STAFF REPORT

PROJECT: Hill Pond Residences Project Development Plan Major Amendment, MJA #150003

PROJECT DESCRIPTION:

This is a Major Amendment to the approved Hill Pond Residences Project Development Plan approved in February 2015. The amendment adds lot lines between the units so that each residence is on its own lot. The overall boundary of the project is unchanged.

HILL POND PROPERTIES PDP
VARIANCE REQUEST

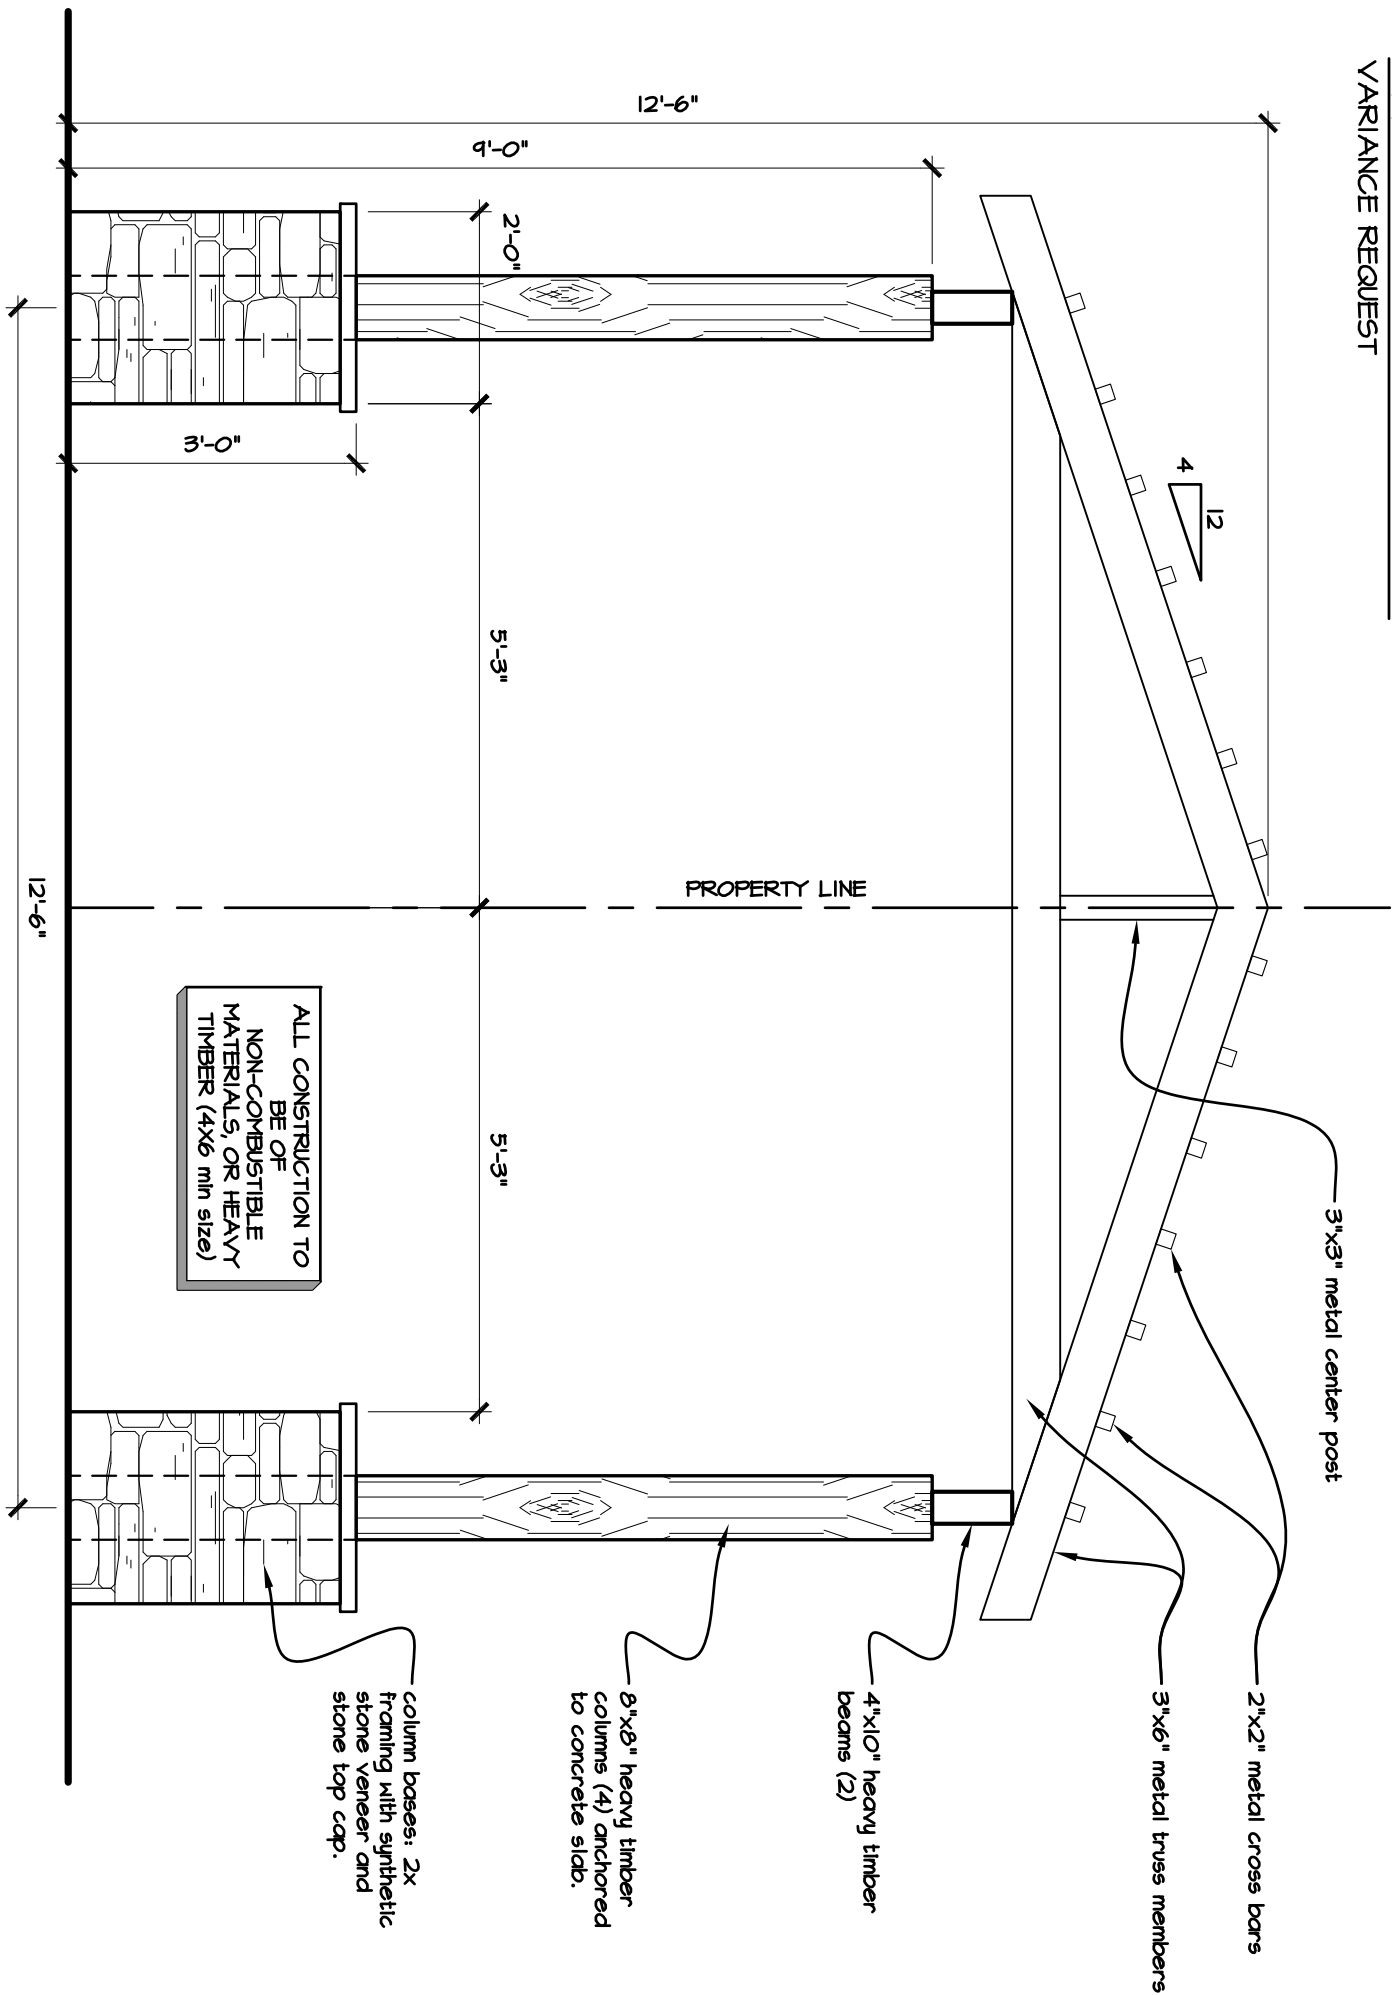
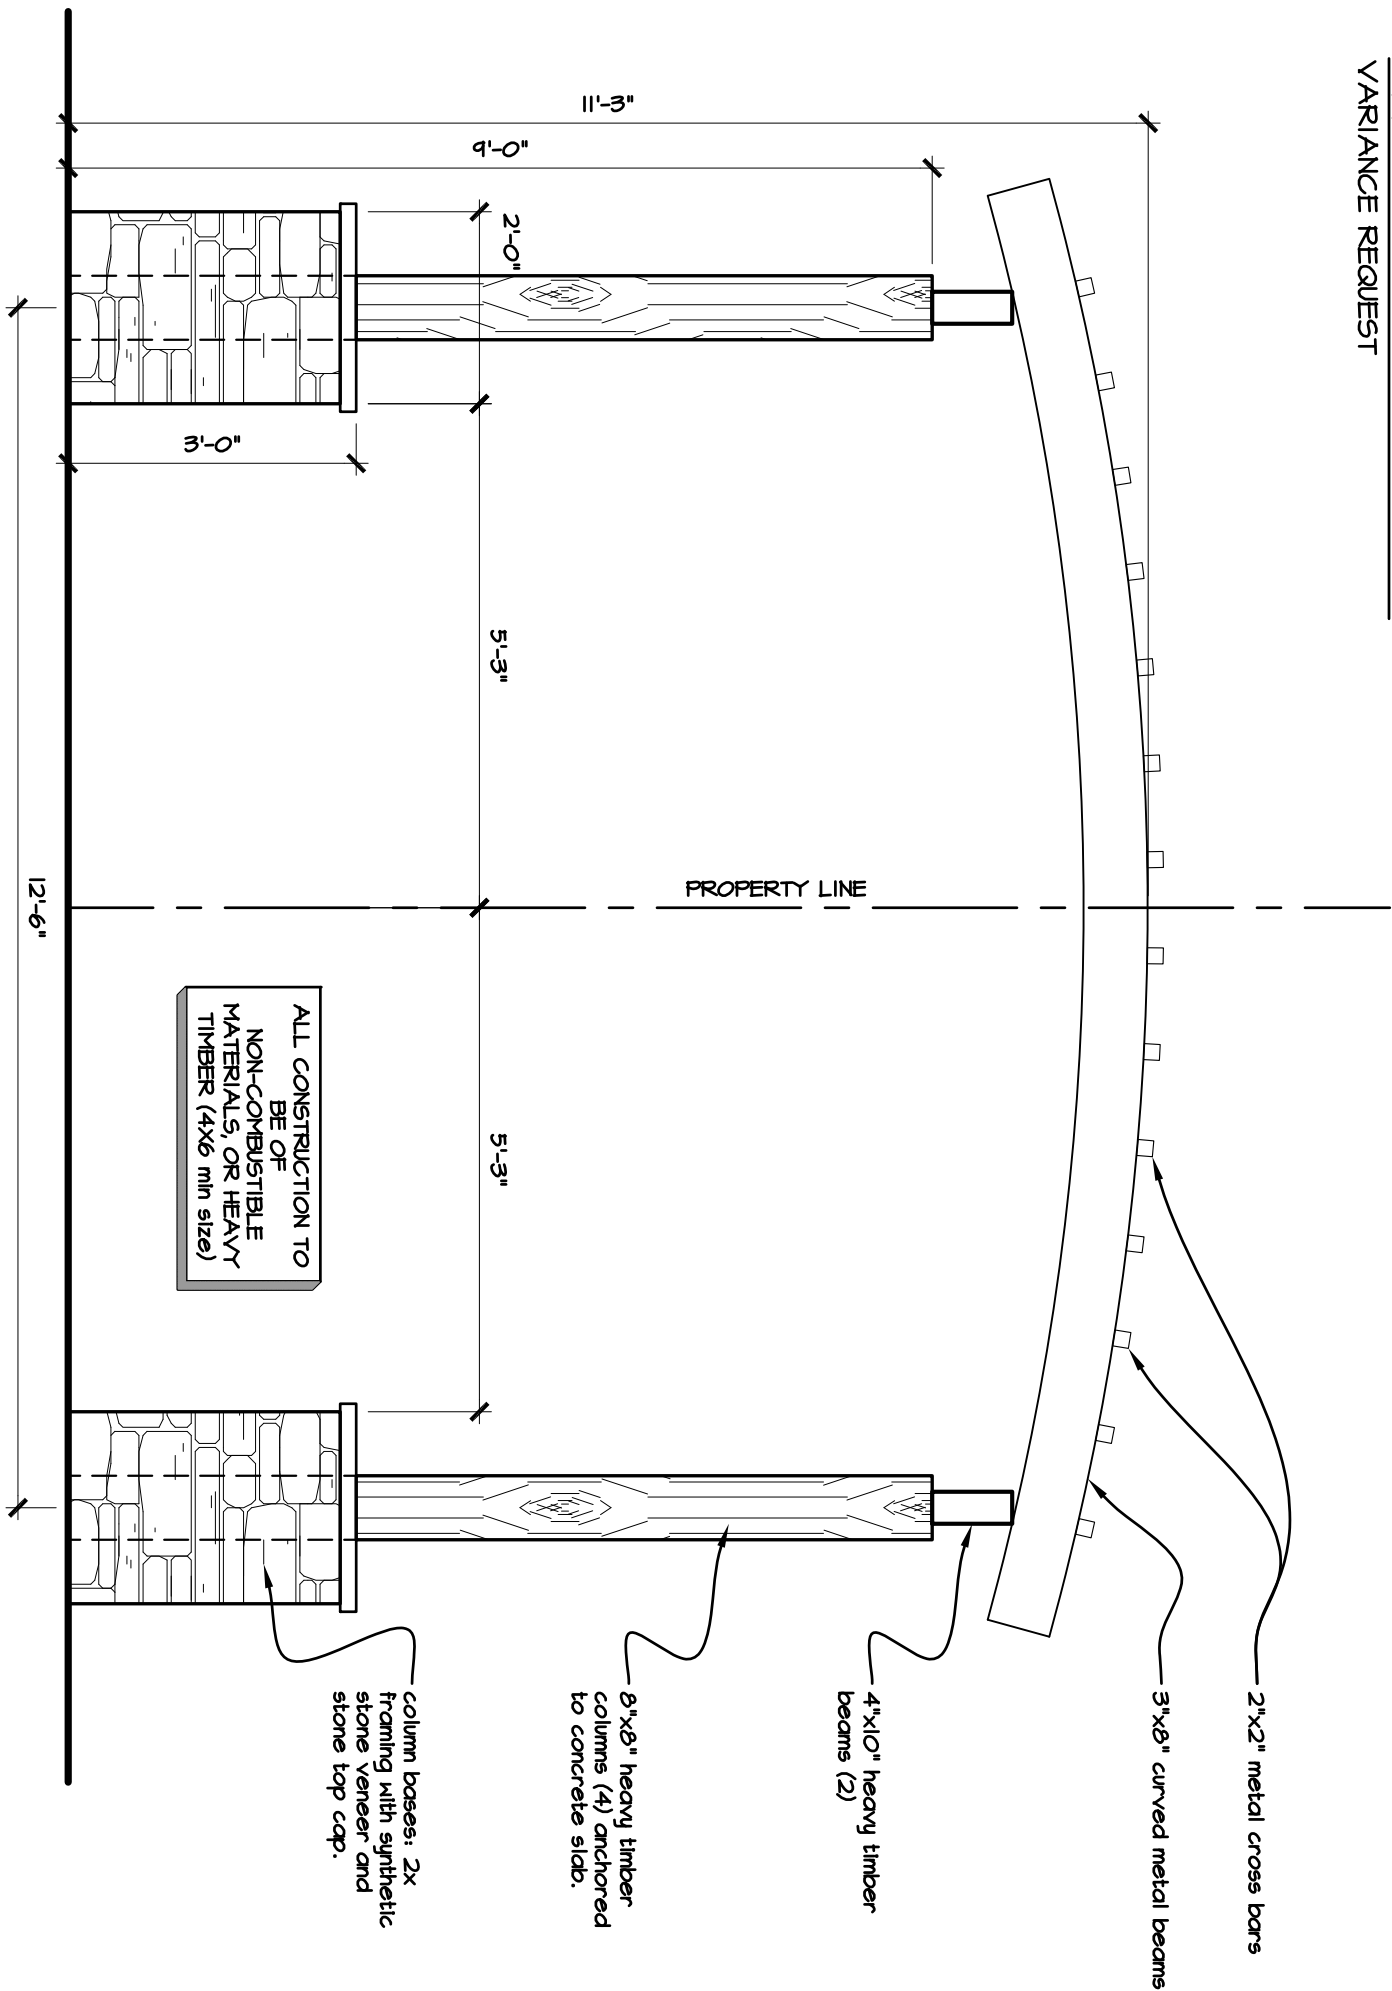
The need for the re-plat is driven strictly by financing and marketing concerns and not by any desire to change the approved design. Indeed, the site design has very intentionally been left unchanged, as it has been accepted and approved by the design team, the owner and the PDP process.

However, the current site plan and the new property lines of the proposed re-plat come into conflict with regards to the Entry Trellis features which are shared by 2 dwelling units. These free standing structures will span the new property lines and thereby will be in violation of the International Residential Code (Table R302.1).
